# **6 Indialucie Parkway**

BUILDING PERMIT NO. 5573

Building to be erected for MICHAEL & JENNIFER FLAUGH Type of Permit S.F.R.

**CRITIQUE SHEET**

TYPICAL WALL SECTION  
 (FOR DEPTHS TO 6'-0") N.T.S.

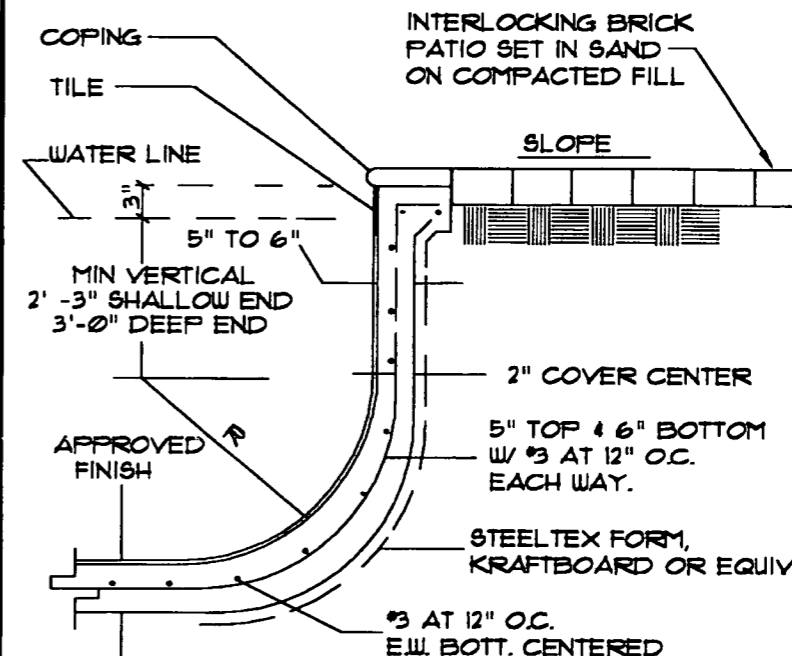
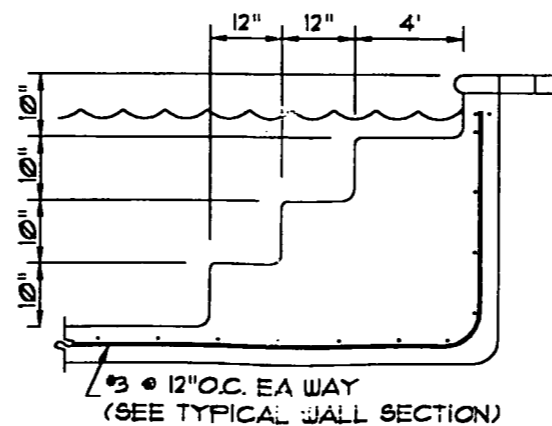
POOL STEEL - STEEL NOT TURNED @ TOP  
OF WALL + #3 MISSING - PER  
SECTION DRAWING
